MOTOR CYCLE, LIGHTWEIGHT, 250 CC, CAN-AM

MODIFICATION INSTRUCTIONS

TITLE MOTOR CYCLE, LIGHTWEIGHT, 250 CC, CAN-AM

MODIFICATION INSTRUCTION NO 1

Fig 1 - Fuel tank mounting
(Dimensions in inches)

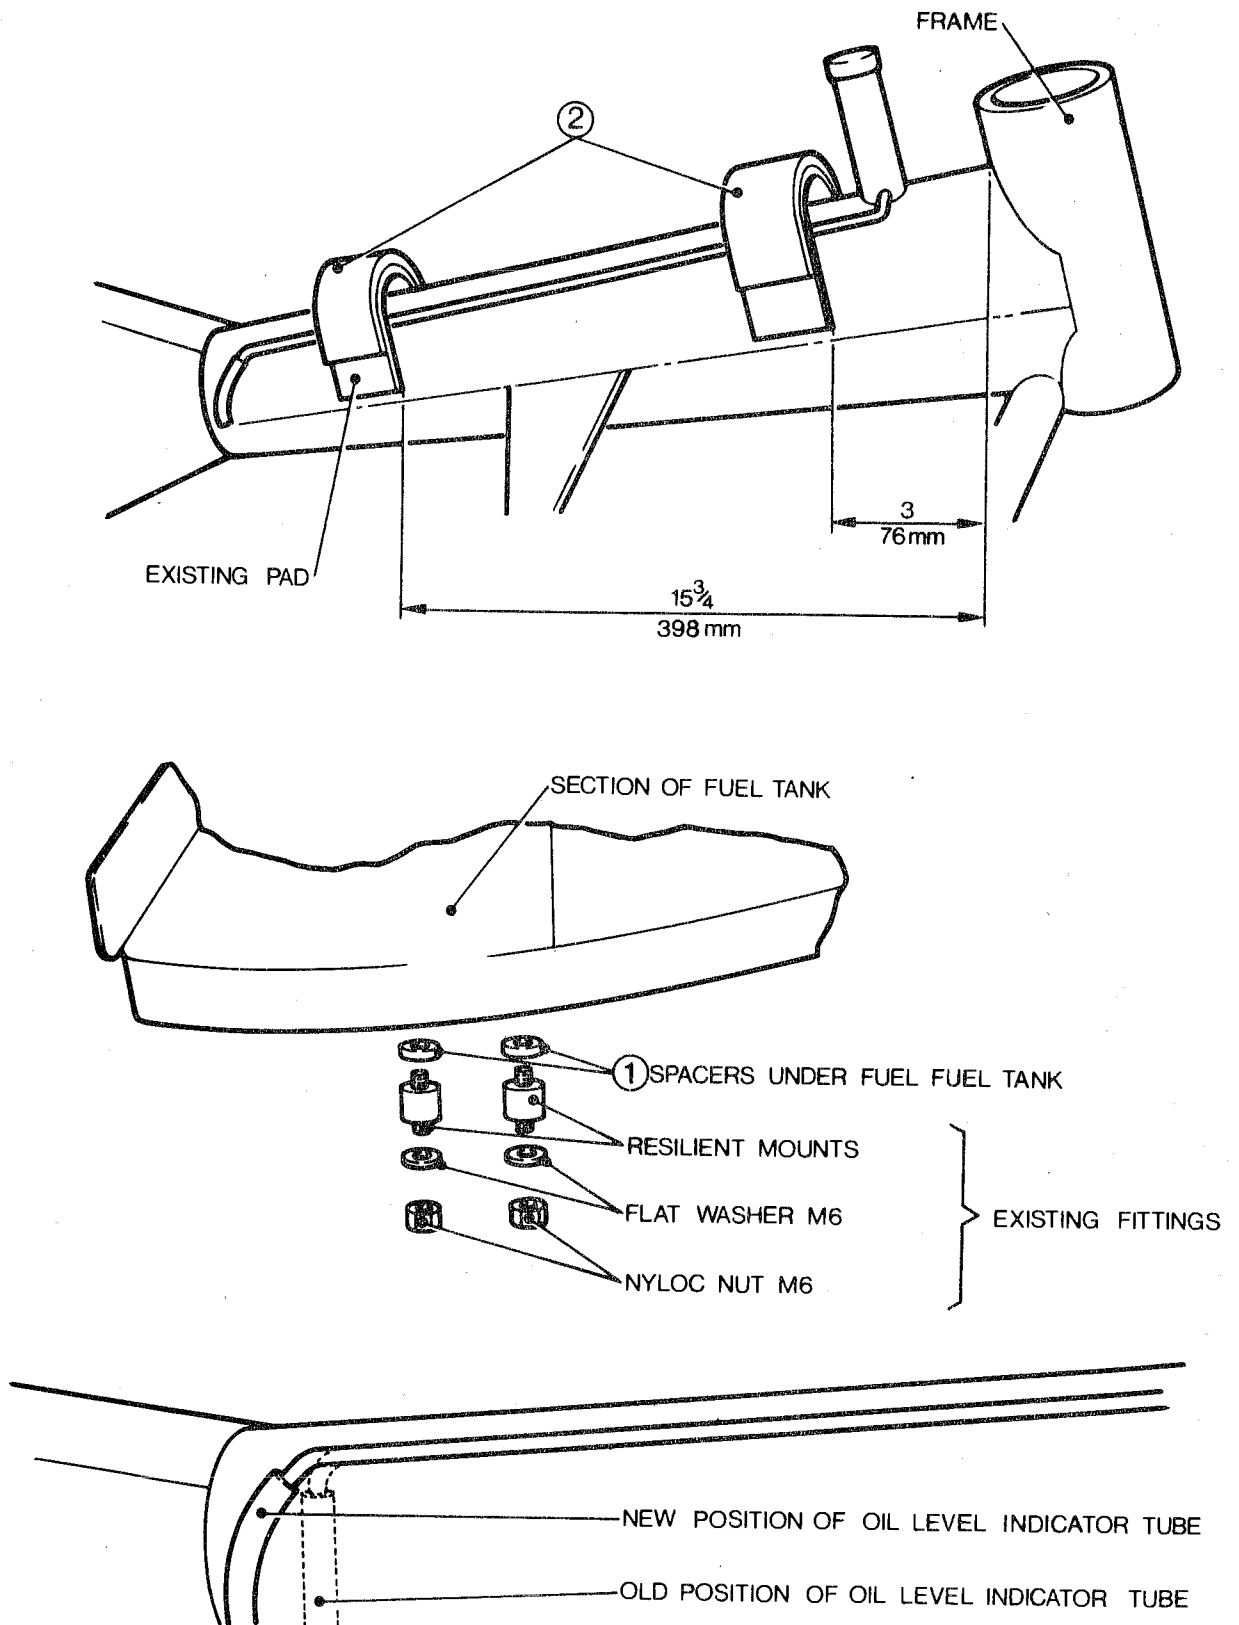
1 This instruction introduces additional packing to the fuel tank mounting, to prevent fuel tank fouling oil indicator tube.

9.4 Unscrew the two resilient mounts from the base of the fuel tank, fit one spacer (item 1) to each mount as detailed in Fig 1 and refit mounts to fuel tank.

9.5 Reposition existing foam pads with additional pads (item 2) on frame as detailed in Fig 1.

9.6 Remove oil level indicator tube from oil pipe line, reset end of pipe line as shown in Fig 1 and refit indicator tube.

9.7 Refit fuel tank to frame ensuring that it is fitted as far to the rear as resilient mounts will allow and that there is sufficient clearance between rear of tank and oil level indicator tube.

If there is insufficient clearance increase the offset of the oil pipe line.

Fig 1 - Fire extinguisher support plate
(Dimensions in inches)

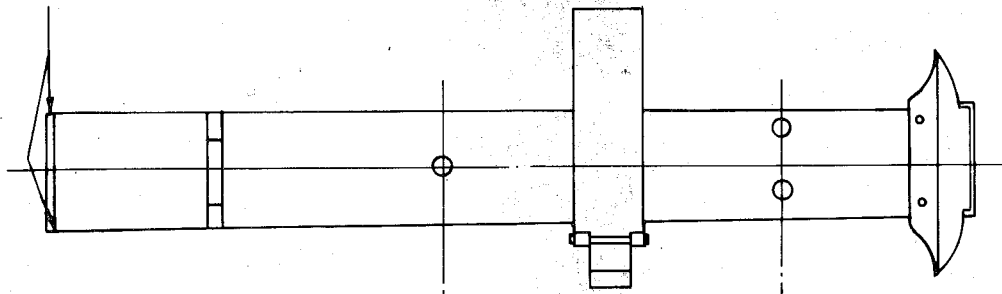
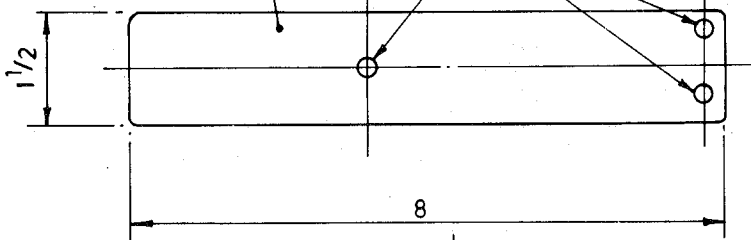
9.2 Refer to Fig 1, manufacture a support plate from steel strip (item 1) to the dimensions shown. Using the fire extinguisher bracket as a template drill three 2 BA clearance size holes in the positions shown, the two holes on the right hand side are to be drilled as near to the end of the plate as possible, allowing enough space to accommodate the nuts.

9.3 Weld the three 2 BA nuts (item 3) to the plate, clean the plate, and paint so as to conform with the paint scheme of the motor cycle.

9.5 Locate the support plate as shown, ensuring that the plate is positioned so as to leave clearance between it and the rear mudguard when it is refitted. Weld the support bracket to the frame, touch up any damaged paintwork. Refit the portion of the mudguard removed in para 9.4.

Fig 1 - Centre stand stop plate
(Dimensions in mm)

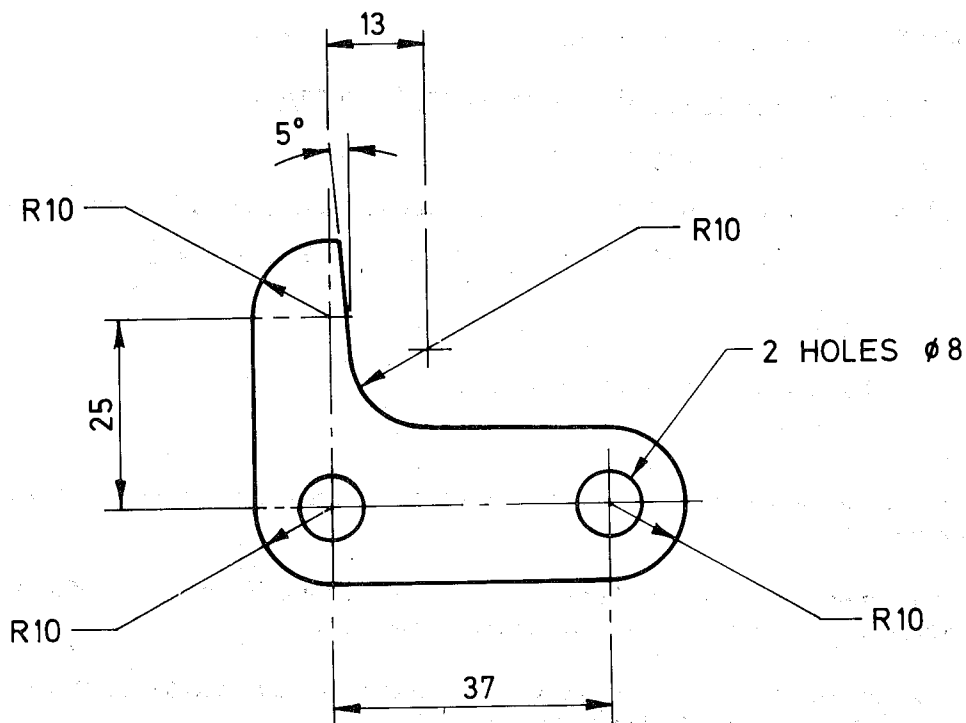
1 This instruction refers to the extending of the centre stand legs and the strengthening of the centre stand stop plates to ensure maximum stability when in the parked position.

9.6 Fit the manufactured stop plates (item 2) using bolts nuts and washers (items 5, 6 and 8).

Fig 1 - GA drawing showing detail of modification to cover clutch

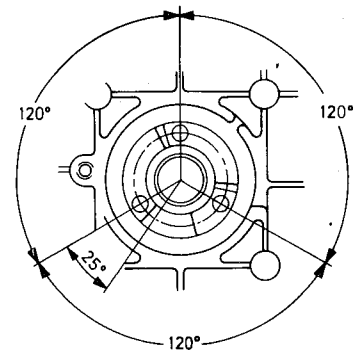
1 This instruction introduces a replacement hardened cam clutch release, and details the fitting of three steel balls to the clutch cover to be embodied, only when heavy clutch operation is experienced.

9.1 From steel bar round (item 4) manufacture a cylindrical spacer (item 5) to the dimensions given in Fig 1.

9.3 Measure and mark off the cover clutch (item 7) as detailed in Fig 1 using method A or B. Once precisely located, centre punch the three hole centres and using a 3.2 mm (1/8 in.) drill bit, drill three starting holes to a depth of 3.2 mm (1/8 in.).

9.4 Install a new 7/32 in. drill bit and the cylindrical spacer on a hand drill. Slide in the drill bit until 5.6 mm (0.220 in.) is protruding over the cylindrical spacer as shown in Fig 1 and tighten the drill chuck. The cylindrical spacer must be leaning against the drill chuck. In order to achieve a hole depth to accurate dimensions of 5.6 mm \pm 0.1 mm (0.220 in. \pm 0.004 in.) a brand new drill but must be used.

Fig 1 - Carrier canvas pannier bag

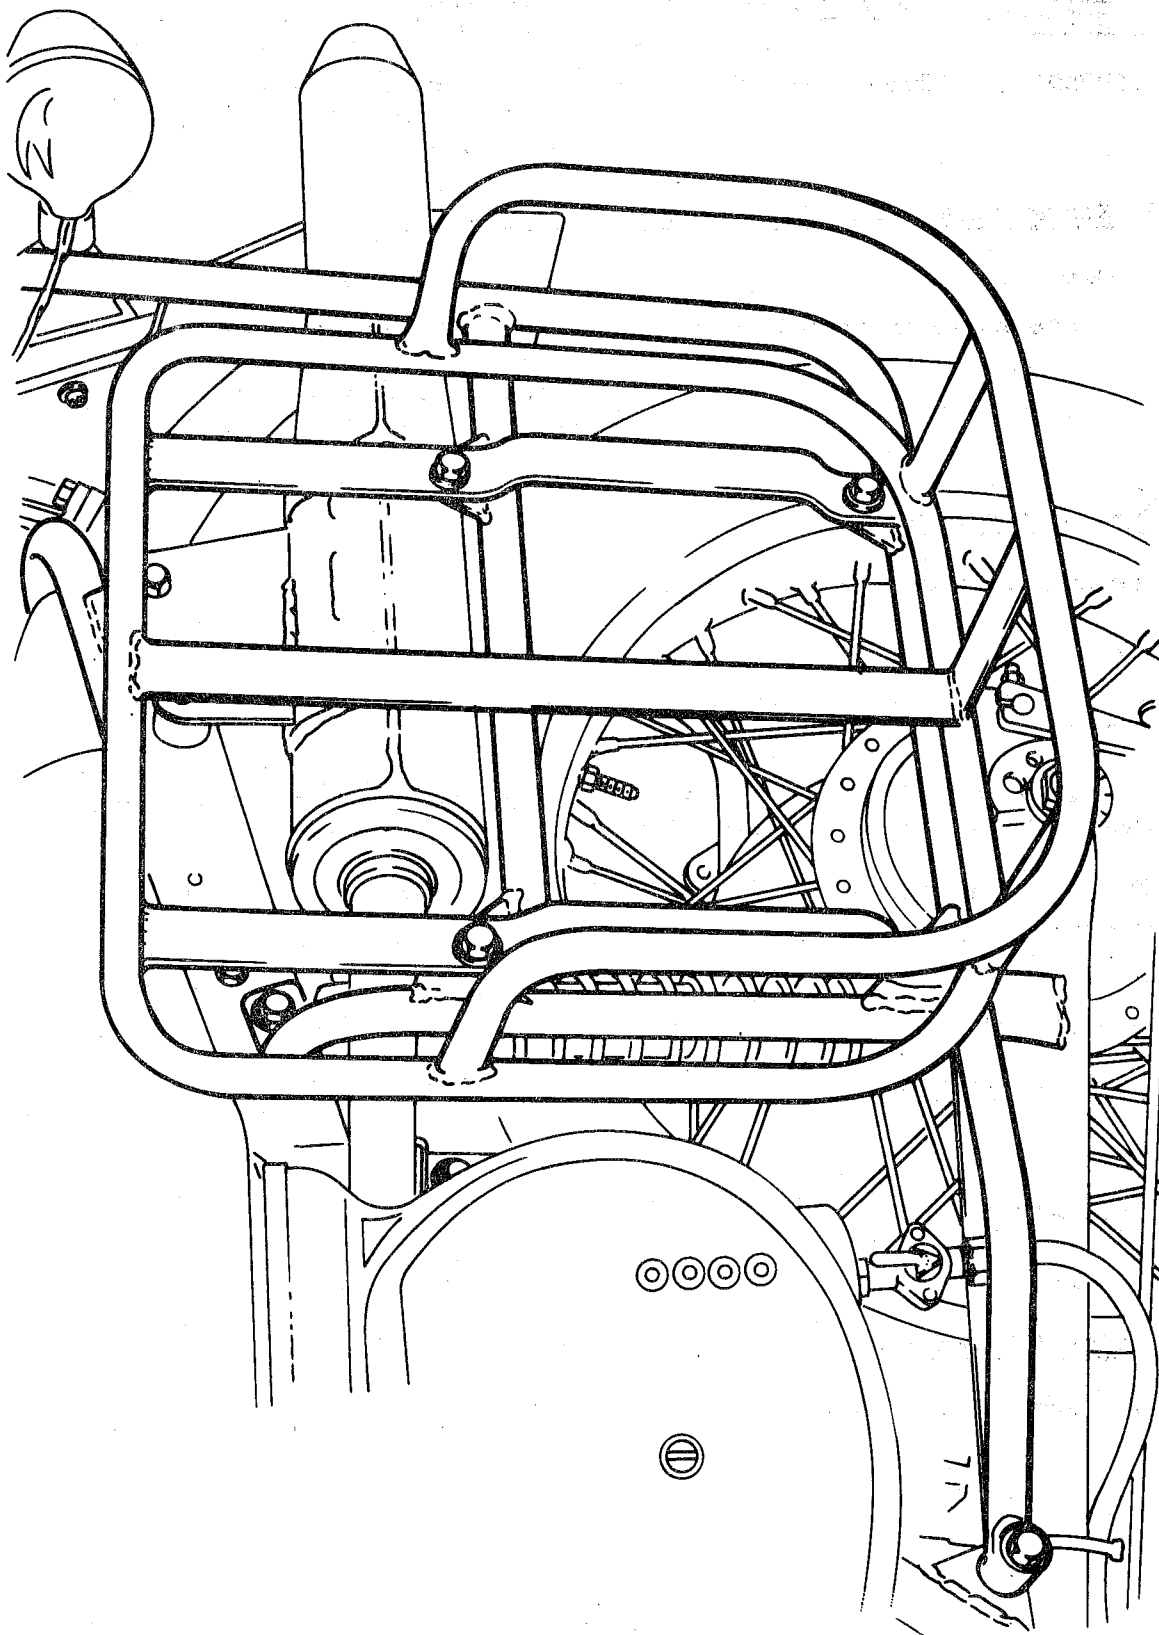
1. This instruction details the fitting of a canvas pannier bag which is issued in lieu of a fibre glass pannier bag now obsolete. On receipt of a canvas pannier bag units are to indent for a carrier, which is to be fitted on to the rack using existing fixings. Canvas pannier bags are to be fitted in pairs, and any serviceable fibre glass pannier bags are to be retained in unit stores and utilised to maintain matched pairs.

9.1 Remove and discard unserviceable fibre glass pannier bag (item 2). Retain fixings and serviceable fibre glass pannier bag.

Fig 1 Chain Case

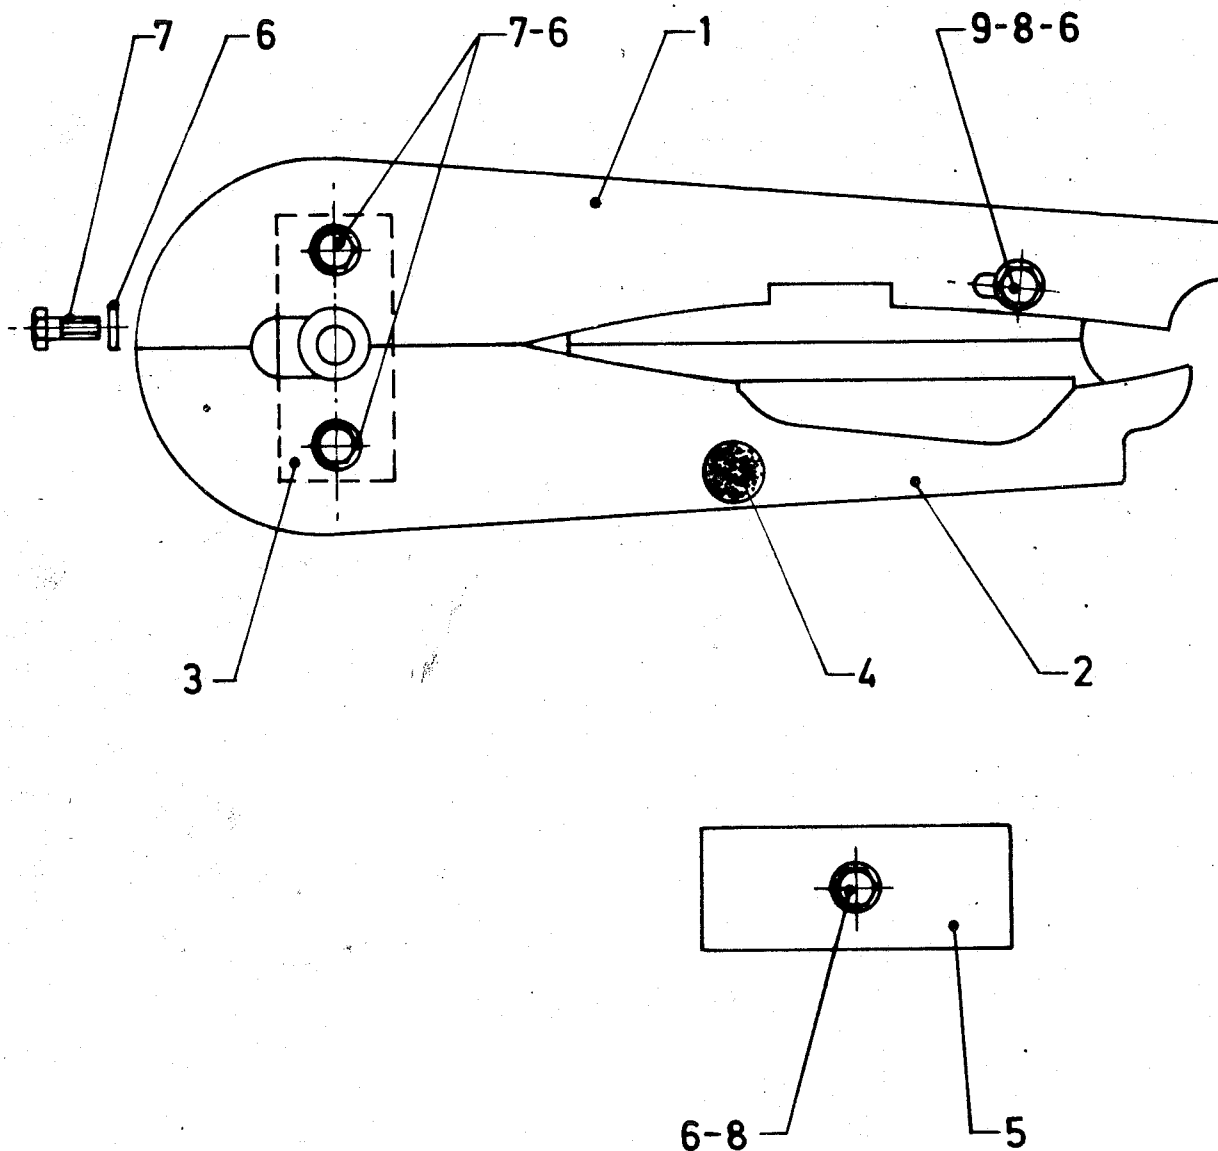
9.2 Remove and discard the existing chain guard (item 11).

9.6 Pull side stand down to half way position. Offer up the lower half of chain case (item 2) easing the rubber sheet around the sidestand lug and loosely fit the two rear mounting bolts and washers (items 6 and 7).
